Kingston Wharf, Shoreham-by-Sea
Noise & Vibration Impact Assessment

Final Report
28th November 2022
1177.001R.2.0.JP

7th Wave Acoustics (7wa) has been appointed by PMC Construction Ltd, to prepare a noise and vibration assessment to support the discharge of Conditions 37 and 47 attached to the planning consent (Ref: AWDM/0204/20) [1] for the new mixed-use development at Kingston Wharf, Shoreham-by-Sea.

Figure 6.2: Wall Detail – Lift Shaft Lining to Habitable Rooms

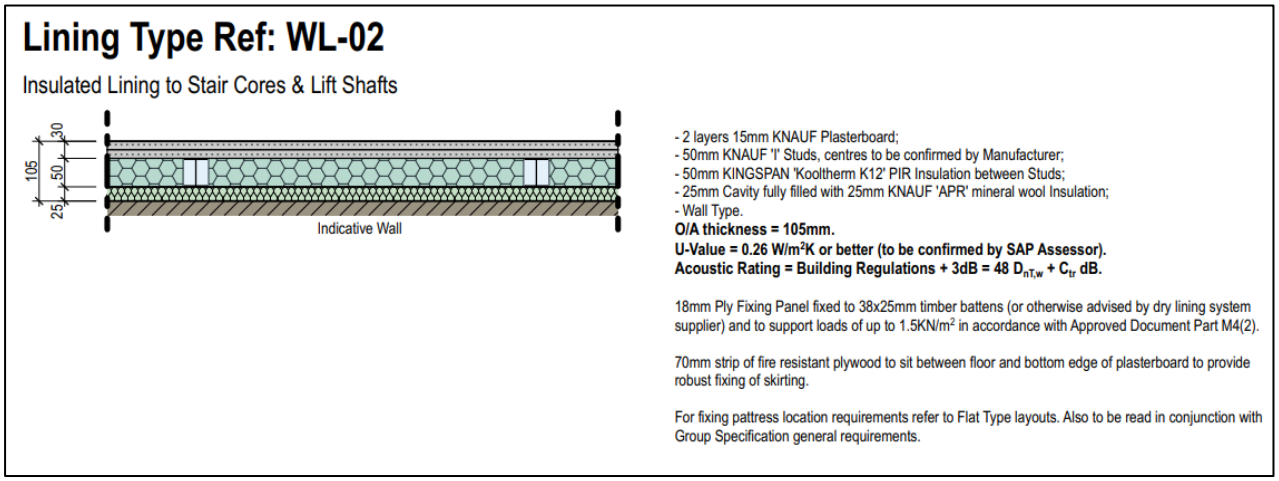
In order to limit the transmission of noise and vibration where the lift shaft is adjacent to habitable rooms (bedrooms, living rooms, kitchen diners, dining rooms etc.), the following wall lining will also be adopted, as shown in Figure 6.2 (**Drawing no. Wall Types Sheet 1a Rev T2**):

To provide an indication of the likely sound insulation performance that can be expected from the wall system between the lift shaft and habitable rooms on site, the wall system has been modelled using INSUL V9. The calculation predicts R_w+C_{tr} 72=dB (+/- 3dB) (R_w 84dB, C_{tr} -12dB). The INSUL calculation is shown in Figure A10 of Appendix A.

Based on the estimated sound insulation of the proposed wall partition, and allowing for a reduction in the sound insulation performance by -10dB due to flanking transmission, in order to comply with the noise criteria of 30 dB $L_{Aeq,1hour}$ set out in Planning Condition 37, the noise levels within the lift shaft should not exceed 92 dB (A).

The current proposal is not entirely in line with the guidance provided within Robust Details as the proposed cavity is only 25mm wide.

Notwithstanding any comparison with the details above, it has been shown that the proposal is suitable for controlling noise transfer from the lift shaft into adjoining habitable rooms, however, it is recommended that consideration is given to increasing the cavity to 50mm to match the guidance within Robust Details, should there be sufficient space to do so.

Figure 7.1: Proposed Party Wall Details – Without Concrete Column

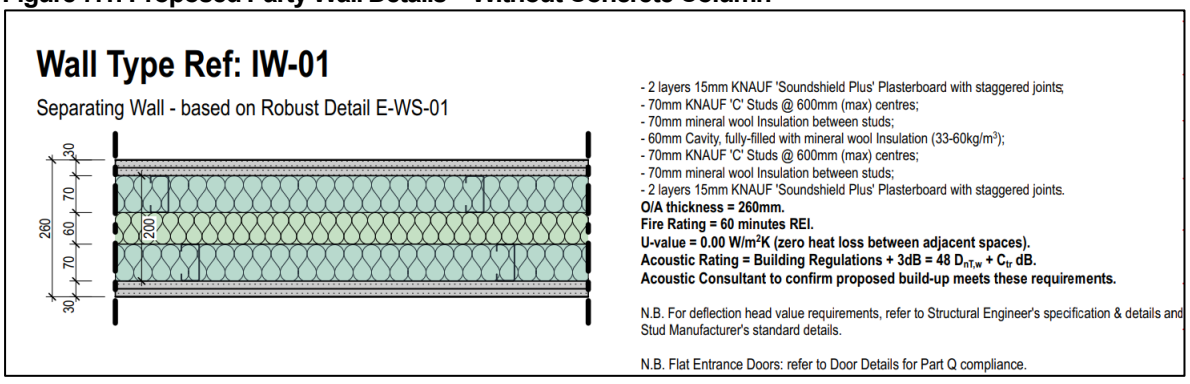
This build-up is based on the Robust Details E-WS-1 separating wall design for the use in lightweight steel frame houses and flats/apartments and is a suitable construction type to achieve the required levels of sound insulation. The E-WS-1 separating wall design is presented below in Figure 7.2.

In order to provide an indication of the likely sound insulation performance that can be expected on site, the wall system has been modelled using INSUL V9. The calculation predicts R_w+C_{tr} 61=dB (+/- 3dB) (R_w 67dB, C_{tr} -6dB) which would indicate meeting the standard E1 requirement between apartment party walls The INSUL calculation is shown in Figure A11 of Appendix A.

- Keep wall linings at least 200mm apart;
- Ensure the batts or quilt cover the whole wall area and are fitted together tightly;
- Make sure batts or quilt are not tightly compressed by the twin frames;
- Ensure that all cavity stops/closers are flexible or are fixed to one frame only;
- Make sure there is no connection between the two leaves except where ties are necessary for structural reasons;
- Stagger joints in wall linings to avoid air paths and seal all joints in outer layer with tape or caulk with sealant; and
- Seal all joints in outer layer with tape or caulk with sealant.

Figure 7.3: Proposed Party Wall Details – With Concrete Column

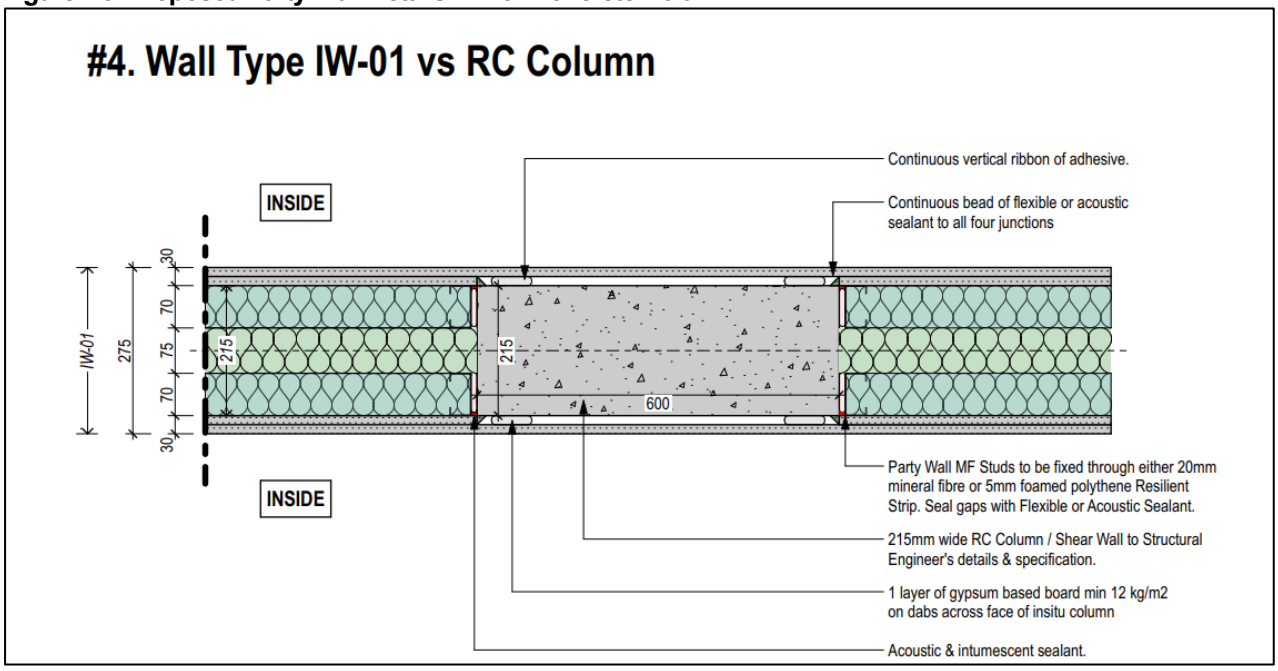
The concrete column itself should provide adequate sound insulation. However, based on experience of similar constructions, a resonant dip in the sound insulation can often be seen at around 63 Hz, which is normally due to small cavities either side of the concrete column, as shown in Figure 7.3. It is recommended that the partition is slightly off-set such that the small gap on one side of the column were removed completely, by running the boards on one side flush against the concrete column (and increasing the cavity on the other side). If the walls cannot be built to such tolerances, it is recommended that to mitigate flanking sound, the small cavity is sufficiently filled with insulation.

Figure 7.4: Proposed Separating Floor/Ceiling Construction

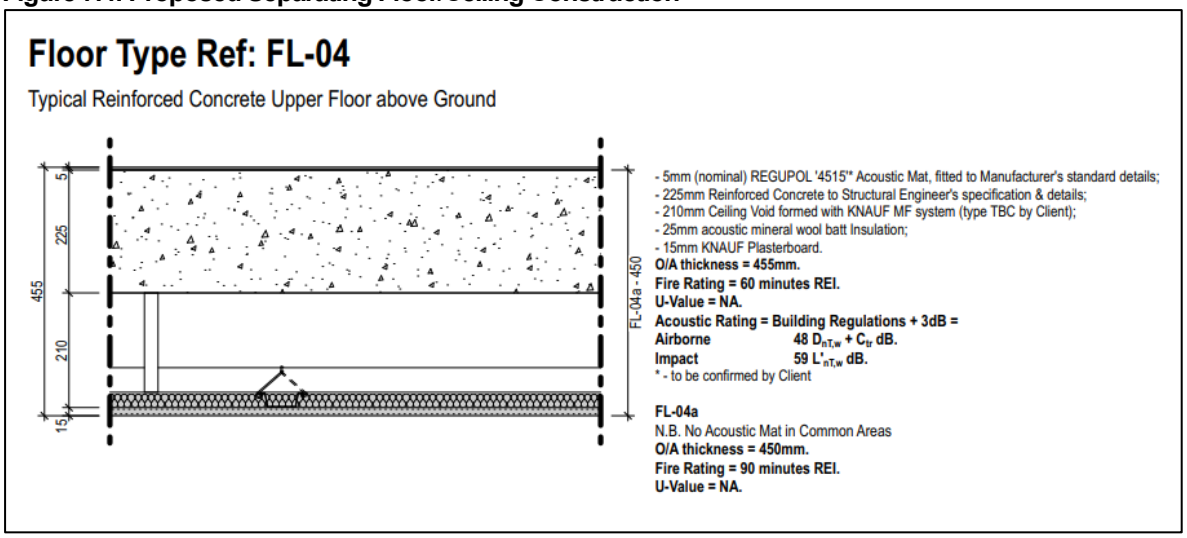
The above build-up is based around the ADE2003 Floor Type 1 system with a concrete base with ceiling and soft floor covering and is similar to the robust detail [7] E-FC-10 presented below in Figure 7.5.

Robust details recommend a minimum ceiling void of 150mm and a minimum of 25mm acoustic mineral wool. The proposal is for 210mm void and 25mm mineral wool. The proposed detail is therefore considered suitable.

The Robust detail requires a 3mm Thermal Economics IsoRubber Top or IsoTubber FR floor covering, however, the selected product (Regupol 4515 acoustic mat) is deemed to be sufficient.

An INSUL calculation of the proposed system predicts R_w+C_{tr} 67dB (+/-3dB) (R_w 73dB, Ctr -6dB) for airborne sound insulation, which would indicate achieving the standard E1 requirement between apartment party walls .

- the floor slab density should be 2200kg/m^3;
- all voids between walls and floors should be filled;
- ensure the Acoustic Mat is fully bonded to the slab with adhesive;
- ensure the Acoustic Mat fully covers the floor surface;
- ensure the ceiling void is a minimum of 150mm and ceiling treatment is installed to manufacturer's instructions;
- ensure that floor slab breaks the vertical continuity of flanking walls;
- ensure that concrete does not enter the cavity and bridge between the two leaves; and
- flanking strips should be installed around the perimeter of the flooring board to isolate floor from walls and skirtings. Flanking strips should be installed to manufacturers instructions.

Figure 7.10: Proposed External Wall to Floor Junction Detail

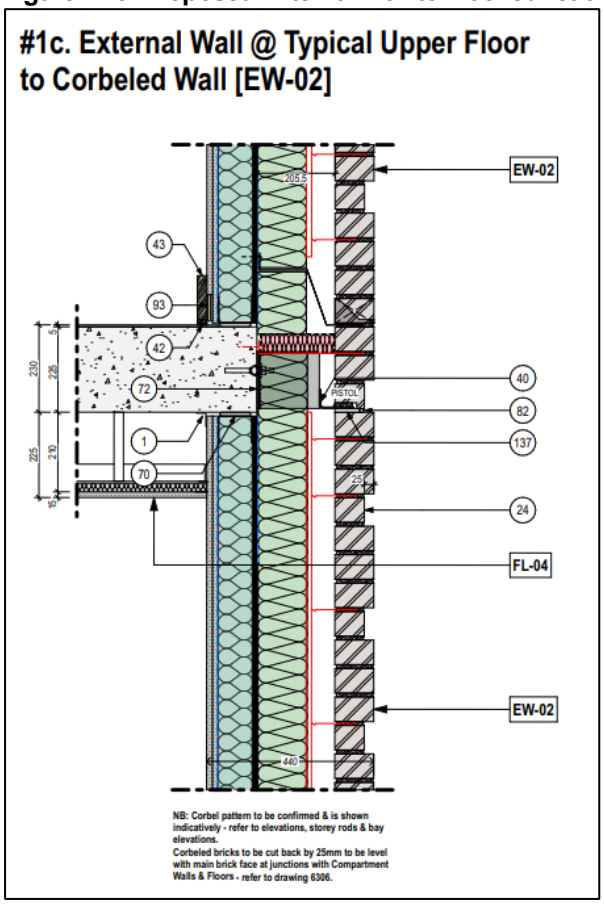
The flanking control considerations above appear to follow most of the Robust Details and includes the use of a flexible cavity stop. However, the proposed detail includes a masonry support bracket, which is understood to take the external masonry load and apply it back to the structure of the supporting building. This product could potentially create a flanking path for noise and care should be taken during installation. As a precaution, it is recommended that the face of the bracket which comes into contact with the floor slab, is wrapped with an isolation material, such as YELOfon screed underlay. It is also important that manufacturers installation details for the masonry support brackets are followed correctly.

Figure 7.12: Party Wall Deflection Head Detail

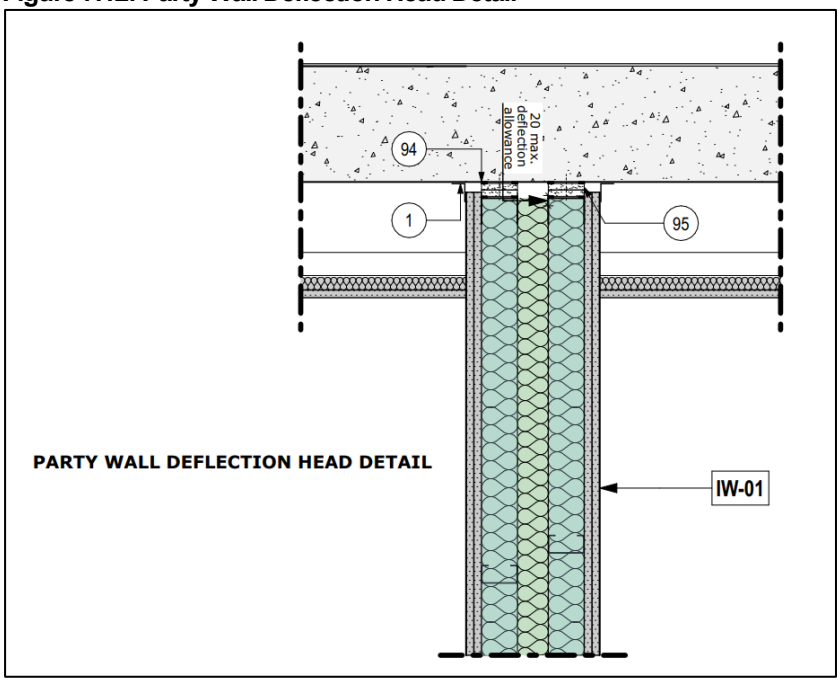
The proposed details appear to be in line with the Robust Details provided above. The use of steel angles and the acoustic sealant are evident.

A detail for the upper side of the floor has not been received. However, all the comments made in section 7.5 will still apply. The key is to ensure the partition is built off the slab.

Edge strips should be included around the skirting and final floor finish.

Figure 7.14: Proposed T-Junction with Concrete Column

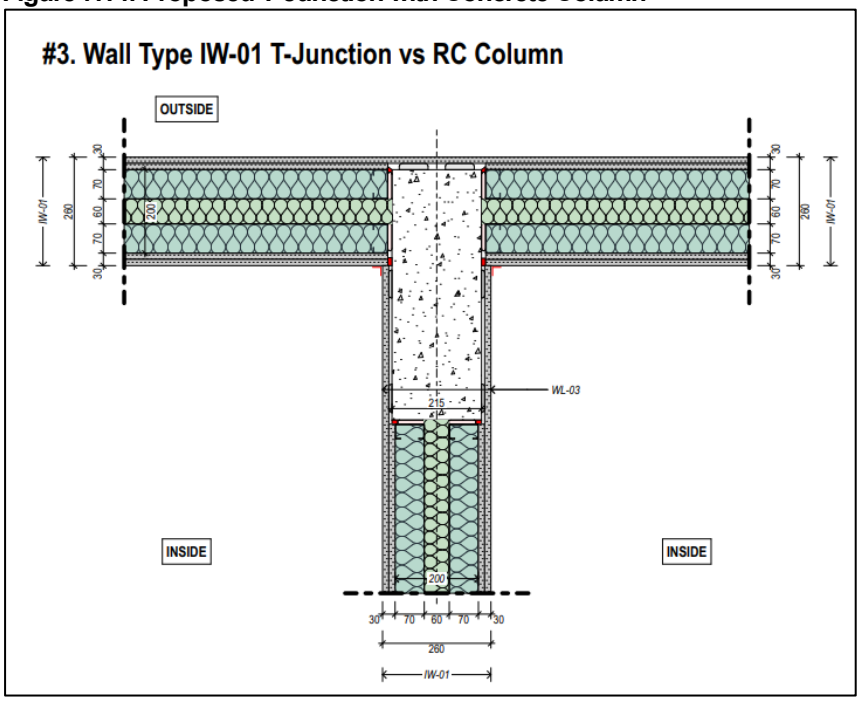
Robust details advises that all joints should be sealed with tape or caulked with sealant and a minimum of 50mm mineral wool is placed between studs for the first 600mm. This is evident in the proposed detail.

Robust details also recommends that steel or timber battens should be positioned around the concrete column to separate the column from the inner or outer partitions. The recommendations provided in Section 7.4 regarding offsetting the concrete column should be followed, if practicable to do so.
